| Well Name: SAN JUAN 28-7 UNIT | Well Location: T27N / R7W / SEC 7 / NWNW / 36.592789 / -107.620697 | County or Parish/State: RIO ARRIBA / NM |

Subsequent Report

Type of Submission: Subsequent Report Type of Action: Plug and Abandonment

SAN JUAN 28-7 UNIT 38

Current Schematic - Version 3

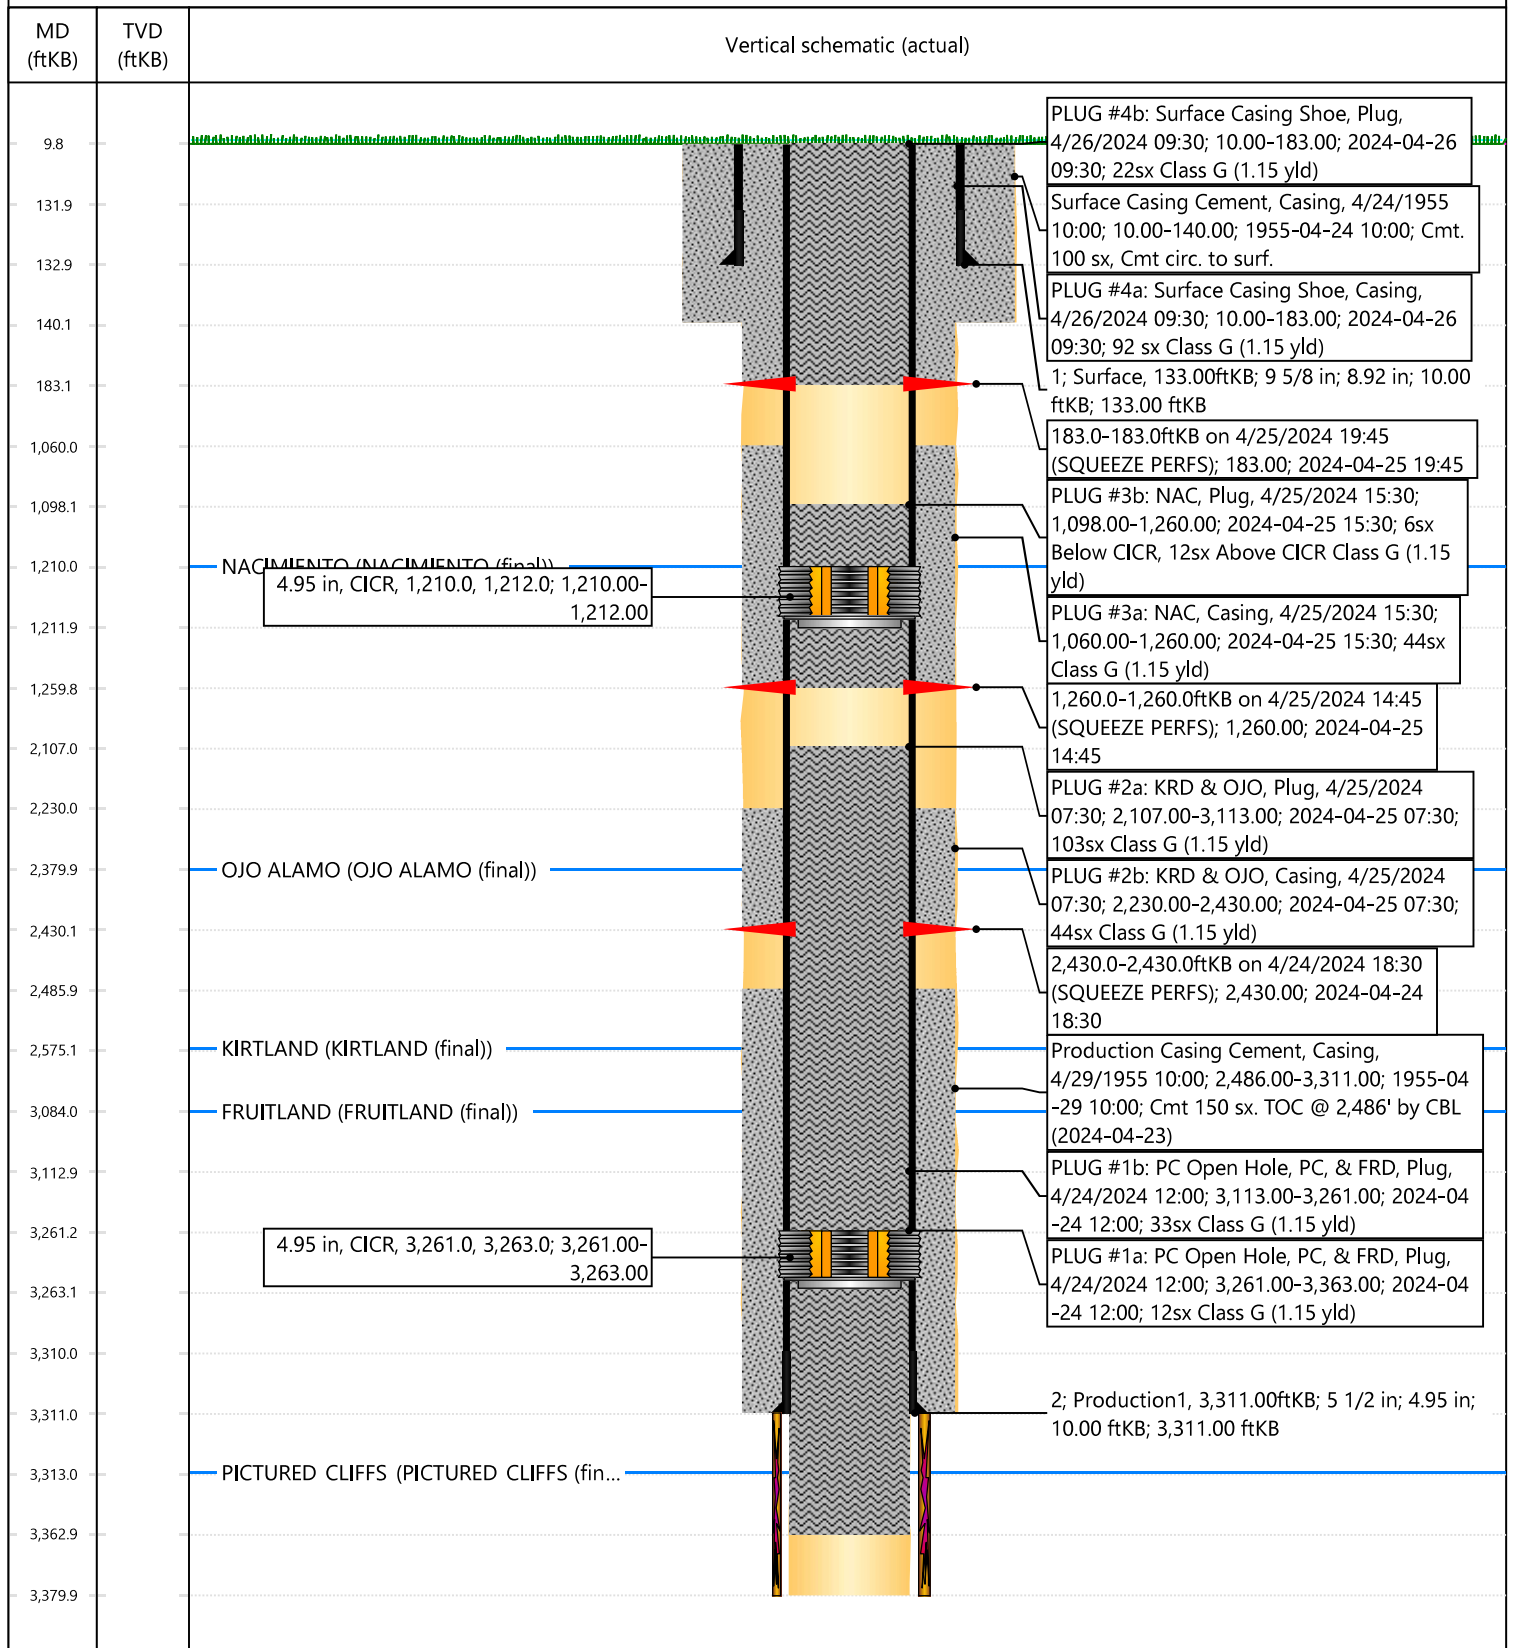
The BLM has approved the NOI to abandoned submission. Note the BLM geologist determined that Ojo Alamo top is higher than operator's pick at 2380.

The BLM request that the Plug 2 TOC (the plug that covers the Kirtland - Ojo Alamo) be raised to 2280.

After discussion, Hilcorp received verbal approval to adjust the KRD/OJO plug to a combined plug. Please see the updated procedure & schematic attached.

Attached is the CBL that was run yesterday (4/23/2024). The CBL shows TOC @ ~2,486'. Additionally, a pressure test was performed to 560 psi which failed.

Based on the results of the CBL and the failed pressure test, Hilcorp requests to move forward with plugging and abandonment of the SAN JUAN 28-7 UNIT 38.

I have attached an updated P&A procedure as well as an updated proposed P&A wellbore schematic.

Upon receiving the approved NOI (attached), Hilcorp needs to adjust the Nacimiento plug design (PLUG #3) based on the BLM's Nacimiento Formation Top pick of 1,210'. In anticipation of pumping this plug, below shows Hilcorp's updated plug design for the Nacimiento:

- PLUG #3: 62sx of Class G Cement (15.8 PPG, 1.15 yield); NAC Top @ 1,210':
 - TIH & perforate squeeze holes @ +/- 1,260'. RIH w/ 5-1/2" CICR and set CICR @ +/- 1,210'. TIH w/ work string & sting into CICR. Establish injection.
 - Pump 44sx of cement in the 5-1/2" casing X 8-3/4" open hole annulus (est. TOC @ +/- 1,060' & est. BOC @ +/- 1,260'). Pump an additional 6sx of cement beneath the 5-1/2" CICR (est. TOC @ +/- 1,210' & est. BOC @ +/- 1,260'). Sting out of retainer, pump a 12 sack balanced cement plug on top of the CICR. (est. TOC @ +/- 1,110' & est. BOC @ +/- 1,210'). WOC for 4 hrs, tag TOC w/ work string. *Note cement plug lengths and volumes account for excess.

Moving forward, Hilcorp received verbal approval from the NMOCD and the BLM to extend the previously approved PLUG #2 down to 3,113'. PLUG #2 is now as follows:

- PLUG #2: 141sx of Class G Cement (15.8 PPG, 1.15 yield); FRD Top @ 3,084' | KRD Top @ 2,575' | OJO Top @ 2,380':
 - TOO H w/ work string. TIH and perforate squeeze holes @ +/- 2,430'. Establish injection.
 - TIH with work string to +/- 3,113'.
 - Pump a 141 sack balanced cement plug inside the 5-1/2" casing. Displace 44sx cement with 9.0 bbls water through squeeze holes @ 2,430' into the 5-1/2" casing X 8-3/4" open hole annulus (est. TOC @ +/- 2,230' & est. BOC @ +/- 2,430'). This will leave a 97 sack balanced cement plug inside the 5-1/2" casing (est. TOC @ +/- 2,280' & est. BOC @ +/- 3,113'). Wait on Cement for 4 hours, tag TOC w/ work string. *Note cement plug lengths & volumes account for excess.

I have updated the P&A procedure to account for the BLM's COA outlining their updated OJO formation top pick. Please see the revision for PLUG #2:

7. TOOH w/ work string. TIH and perforate squeeze holes @ +/- 2,430'. TIH with work string establish circulation.
8. TIH with work string to +/- 2,625'. Establish circulation.
9. **PLUG #2: 85sx of Class G Cement (15.8 PPG, 1.15 yield); KRD Top @ 2,575' | OJO Top @ 2,380':**
Pump an 85 sack balanced cement plug inside the 5-1/2" casing. Displace 44sx cement with 9.0 bbls water through squeeze holes @ 2,430' into X 8-3/4" open hole annulus (est. **TOC @ +/- 2,230'** & est. **BOC @ +/- 2,430'**). This will leave a 41 sack balanced cement plug inside the 5-1/2" ca +/- 2,280' & est. **BOC @ +/- 2,625'**). Wait on Cement for 4 hours, tag TOC w/ work string. *Note cement plug lengths & volumes account for exce
